THE RESERVES at EAGLE POINT

365 NORTH PICADILLY RD - BUILDING A

22-3219

City of Aurora Building Division
Reviewed for Code Compliance
Approved as Noted: *locke*
Date: Feb 05, 2024
2021 INTERNATIONAL CODES & 2023 NEC

3 FIRST FLOOR 3 BEDROOM HVAC PLAN
 1/4" = 1'-0"

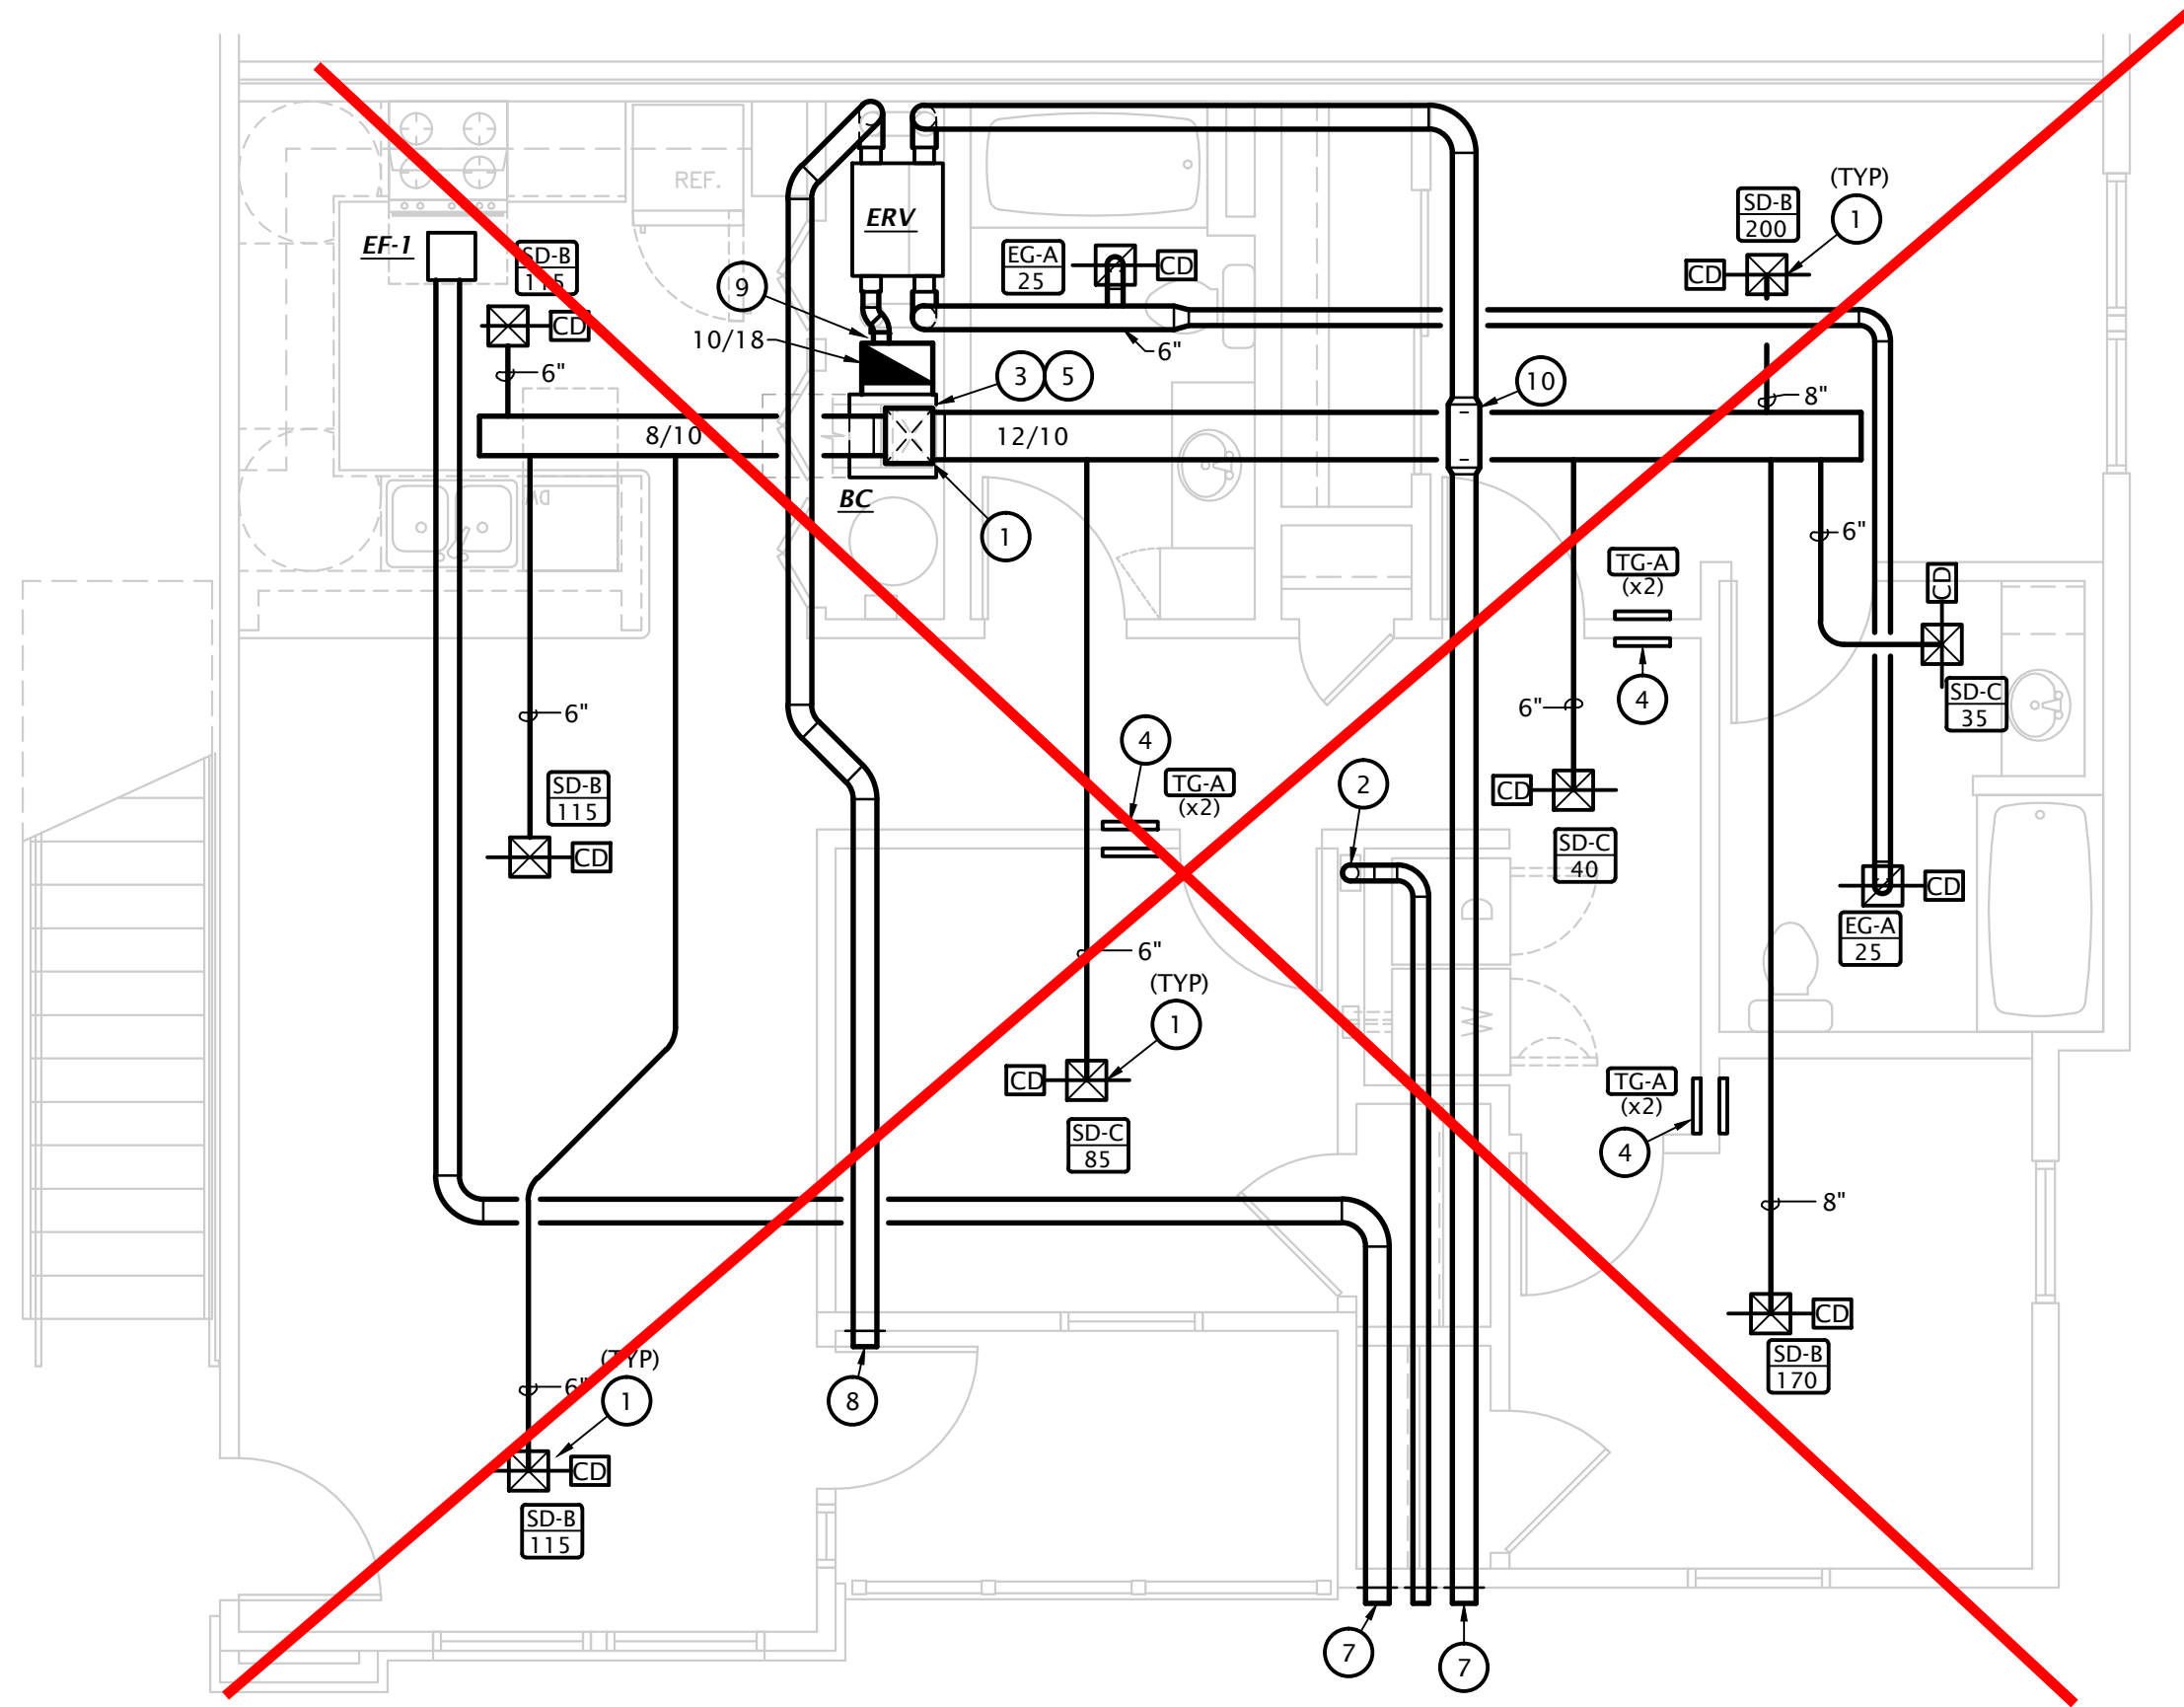
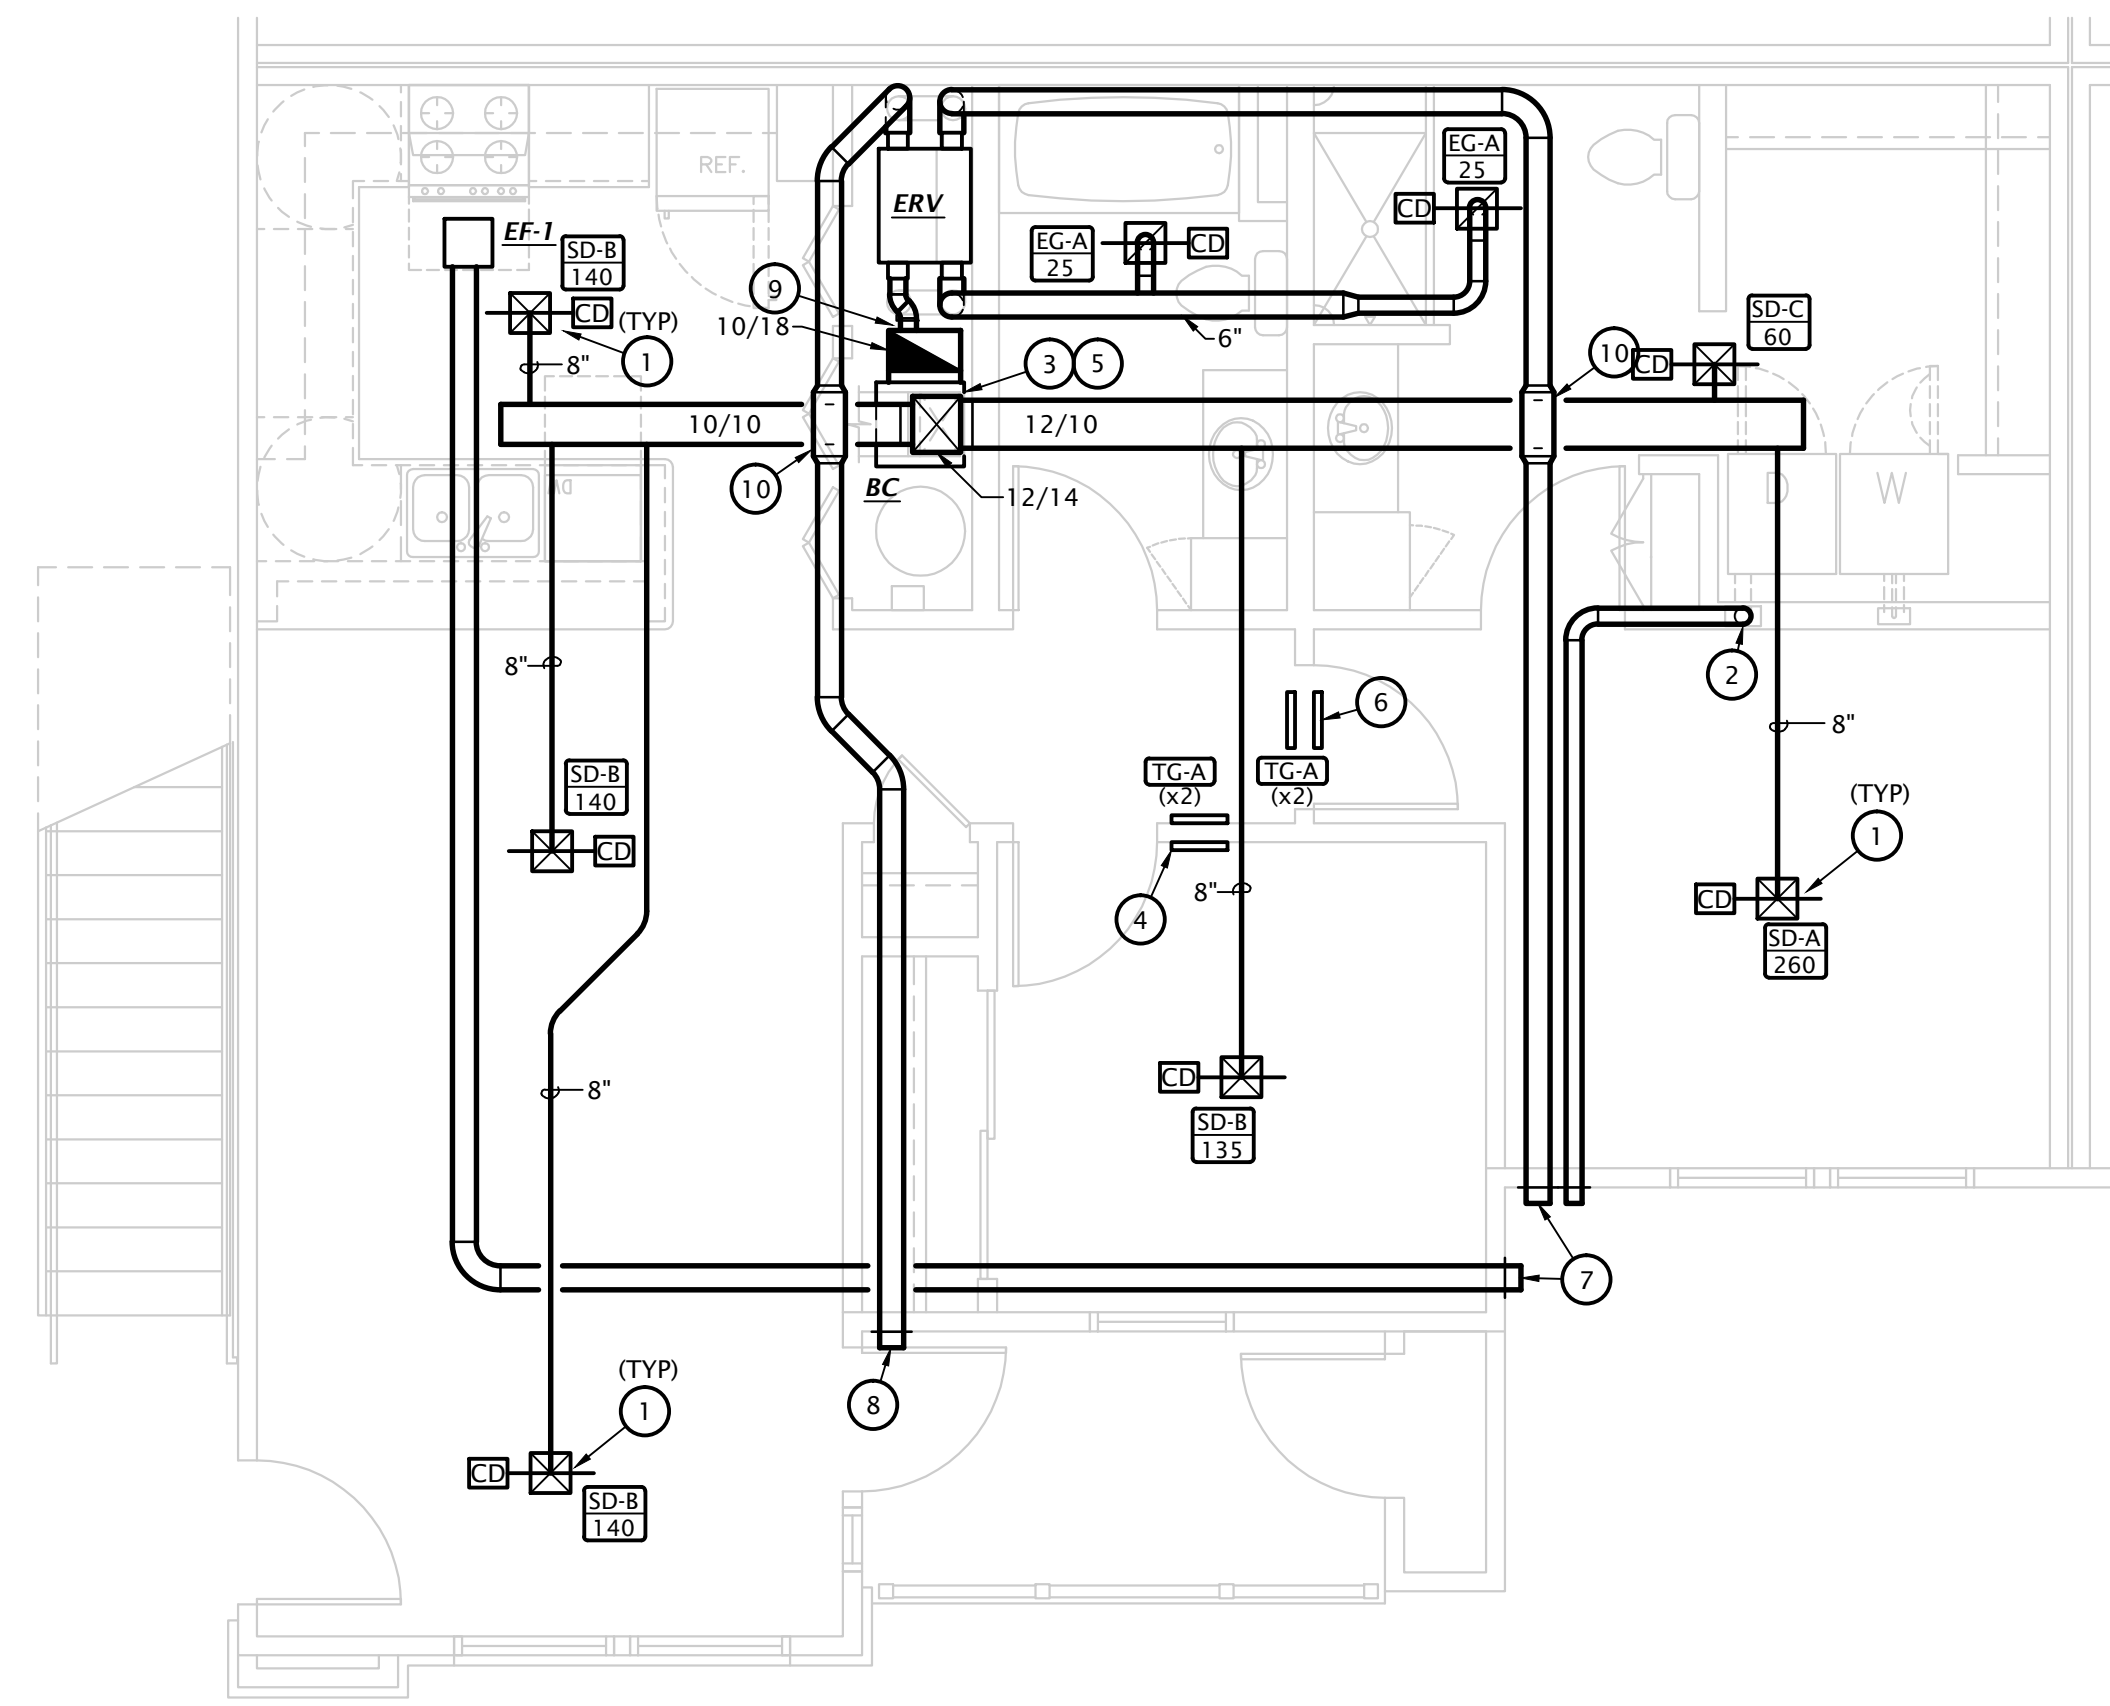
Heating system shall be capable of maintaining 68 degrees F at 3'-0" above the floor.
 2021 IMC R 309.1, IRC 303.10, IBC 1203.1

3-BEDROOM UNIT NOT APPROVED PER THIS PERMIT (TYPICAL).

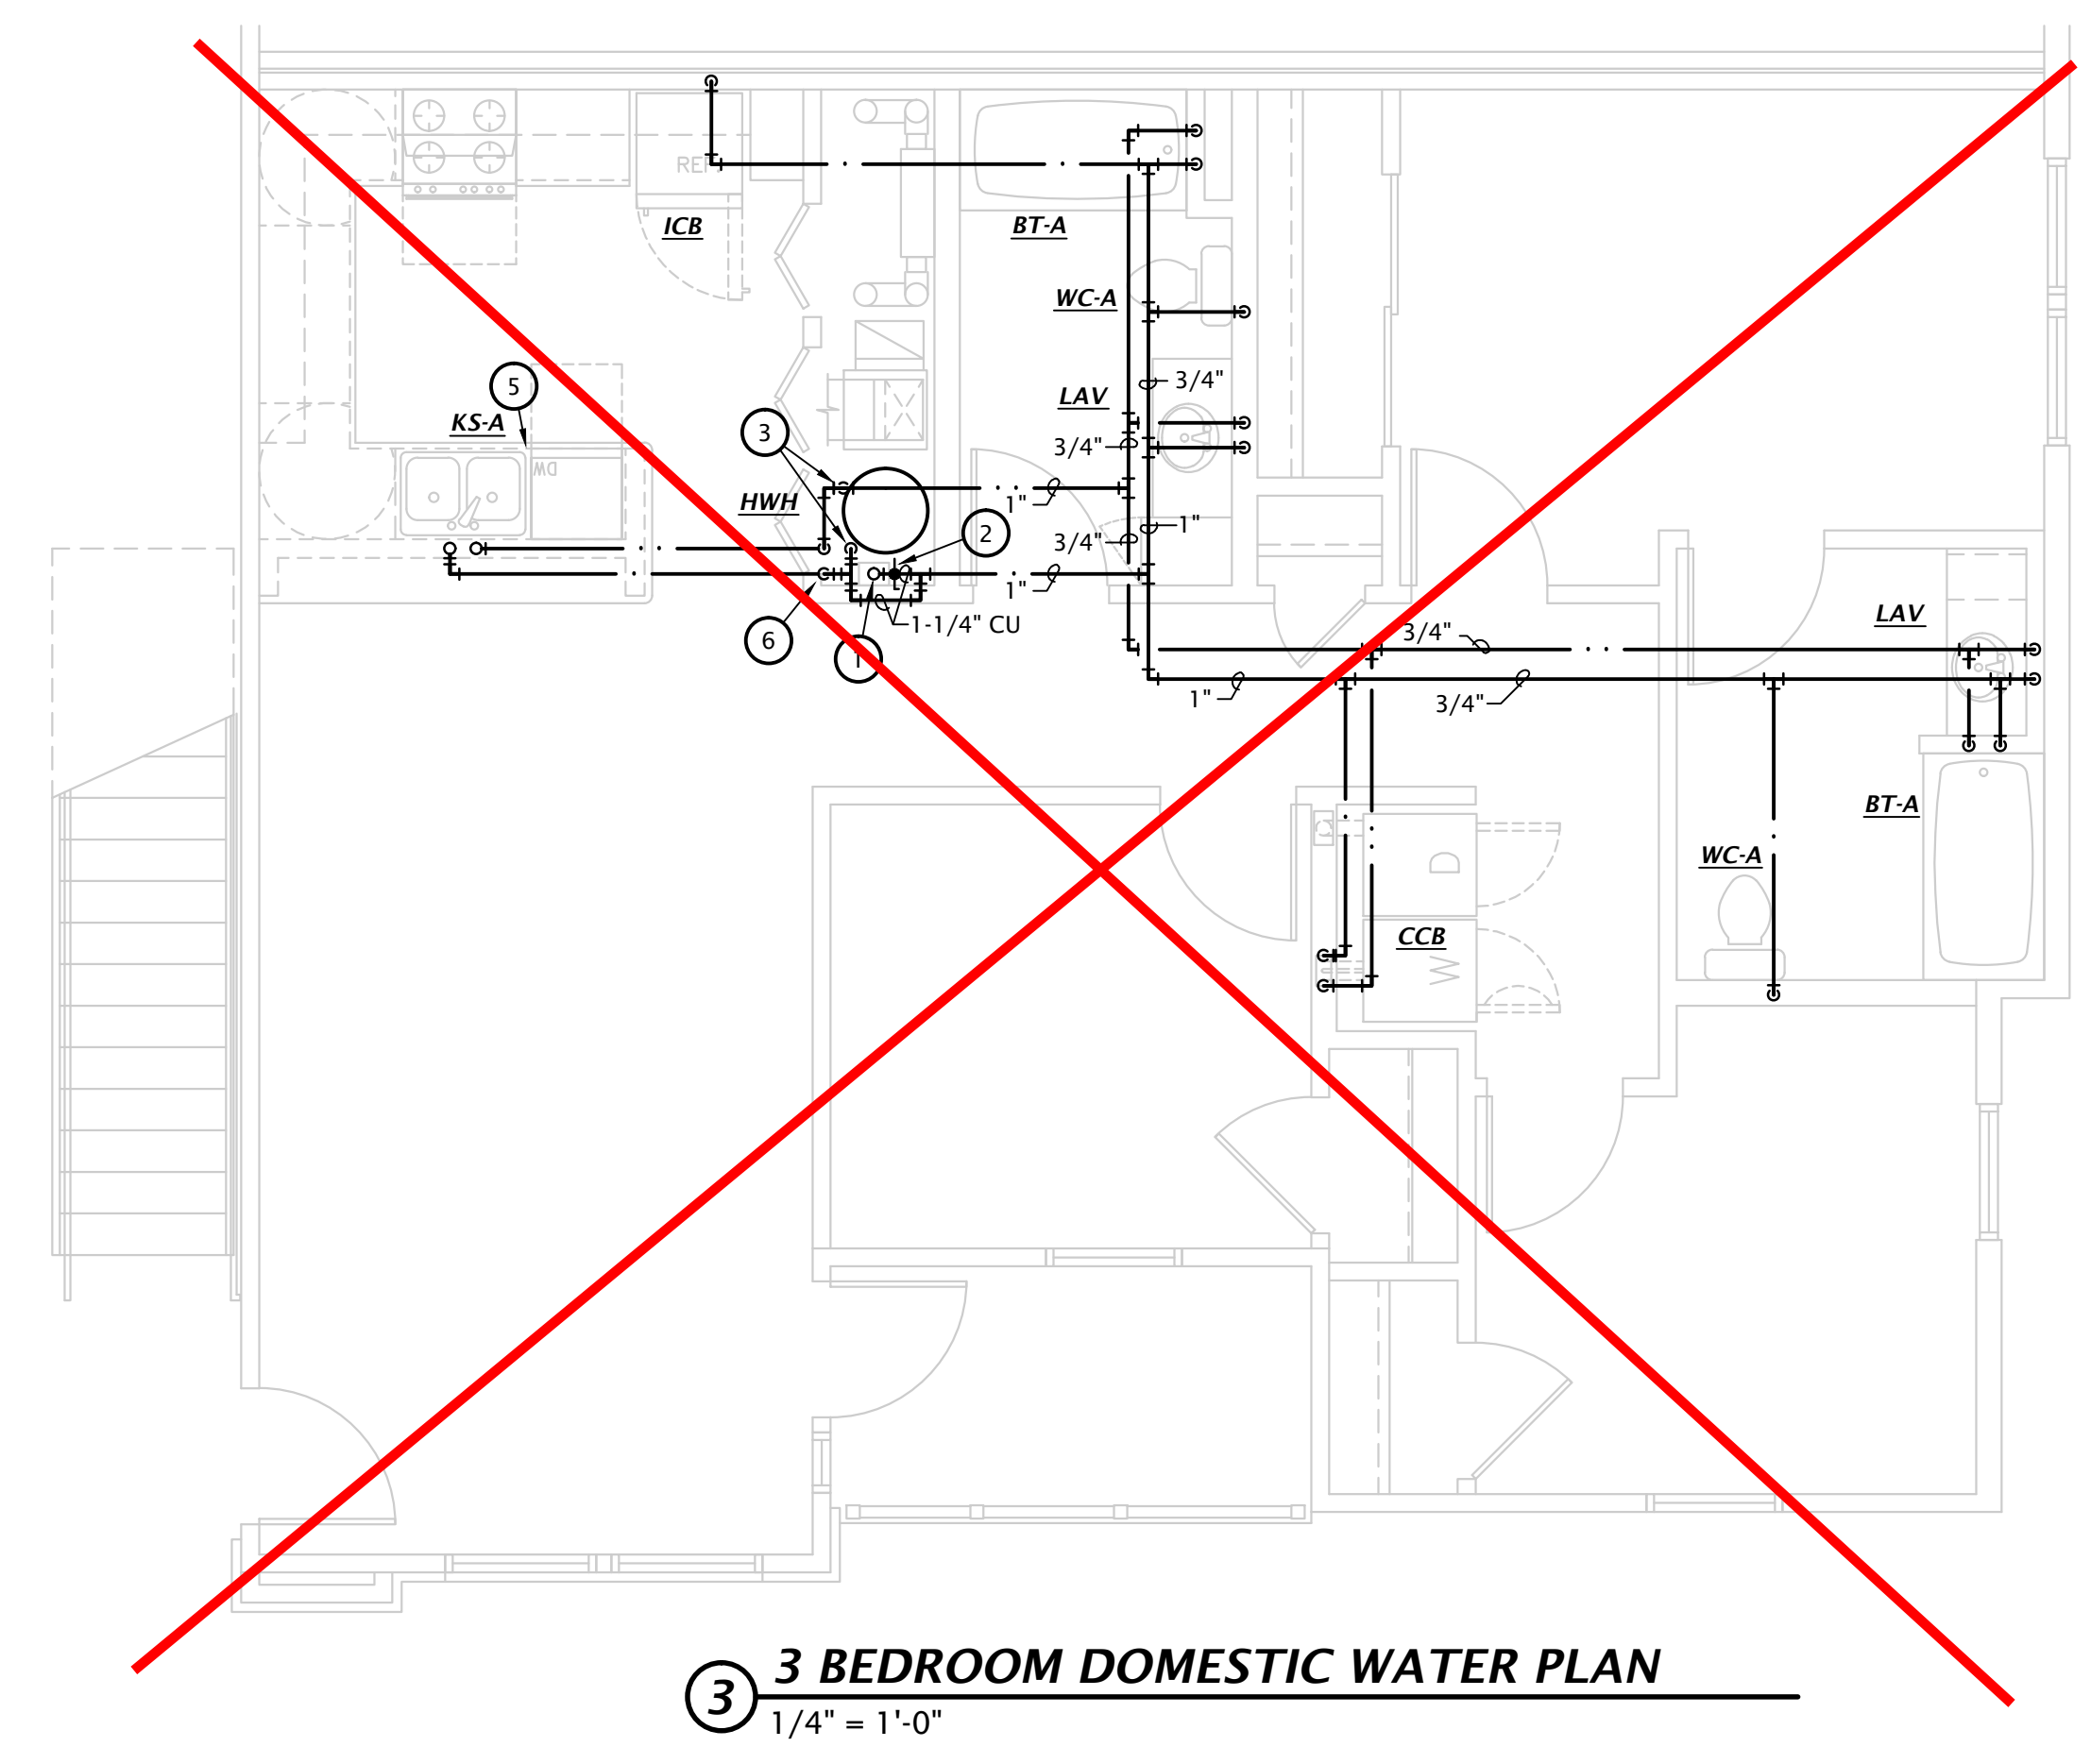
WASTE STACK VENT NOTE:
 ALL OFFSETS ARE PROHIBITED BETWEEN LOWEST AND HIGHEST FIXTURE DRAIN CONNECTION TO WASTE STACK VENT (IPC 913.2)
